Stream Flow Monitoring Report III – Salmon Creek

*Annex Creek/Salmon Creek Hydroelectric Project
(FERC Project No. 2307)*

Alaska Electric Light and Power Company

February 20, 2018

Figure 2 – Fourth Quarter 2017 Corrected Discharge

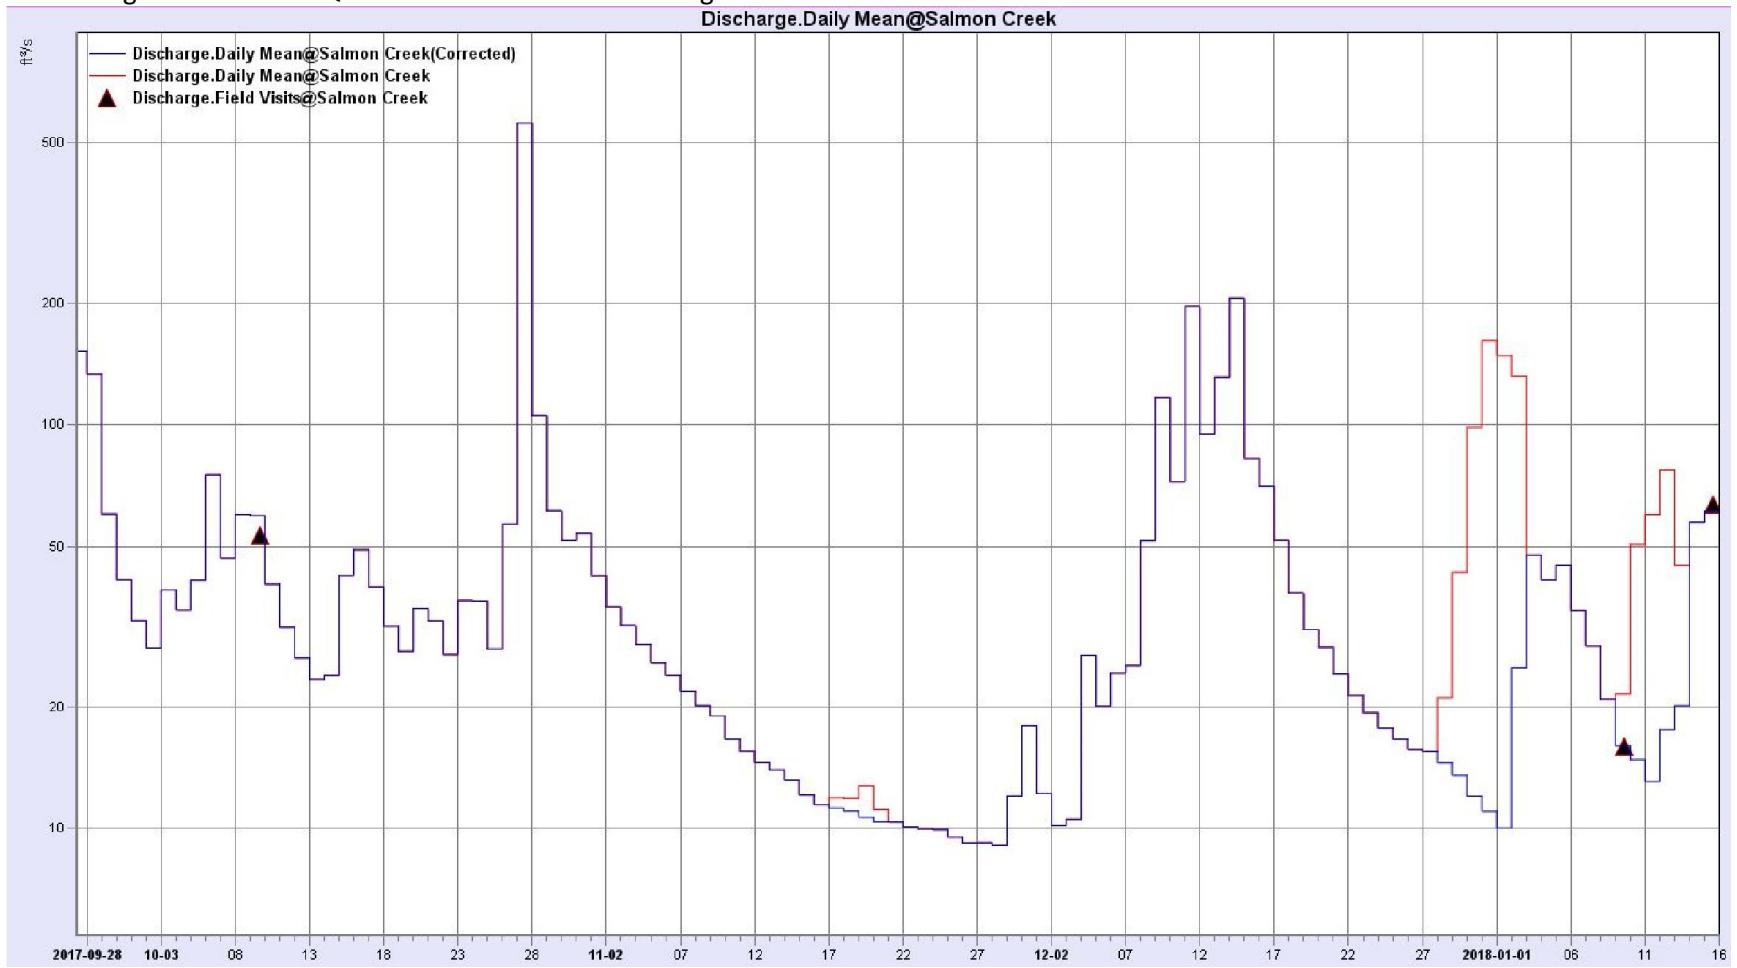
(1) When I look at the website, it seems to show that Nov 24-28, 2017 period did not drop below 10 cfs, but when I look at Appendix B it shows daily averages of 9.9, 9.5, 9.2, 9.2 and 9.1 cfs; these averages probably jive with the log scale graphic in Figure 2. Which one is correct? If the web site is the one that is slightly off, do you plan to rectify it?

Response: (1) The website provides provisional data and finalized data is provided twice annually in this report and includes the stage and stage-variable shift corrections to discharge as defined by the measurements and site visits. The log scale graphics in the report and the

values shown in Appendix B are the correct final values. The finalized data for the 2017 water year has been posted on the website as finalized data.

Rating Curve

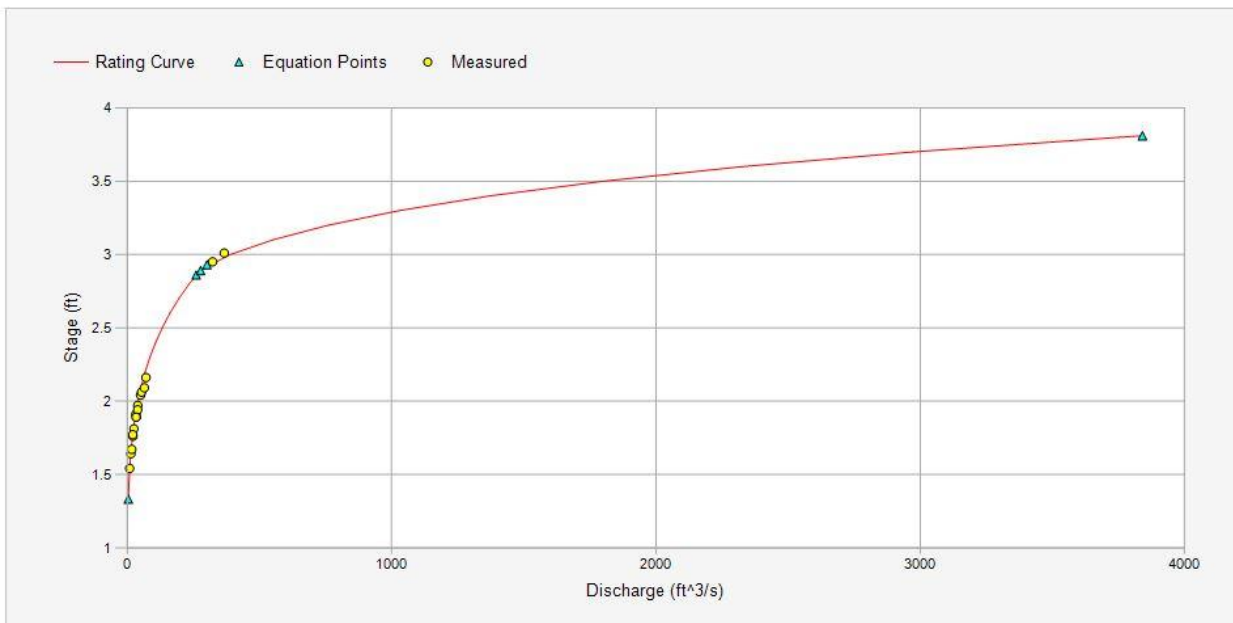
Comment: Kevin Keith with ADF&G responded on February 1, 2018. He requested that a graph of the rating curve (Stage vs. Discharge) along with points showing where the measurements taken during recent field visits are in relationship to the curve.

Response: AEL&P has included *Station Description and Analysis for Salmon Creek Gaging Station near Juneau, Alaska for the 2017 Water Year* as prepared by Alaska Hydrosience in Appendix C of the report. A rating curve is included with the manual measurements identified on the curve.
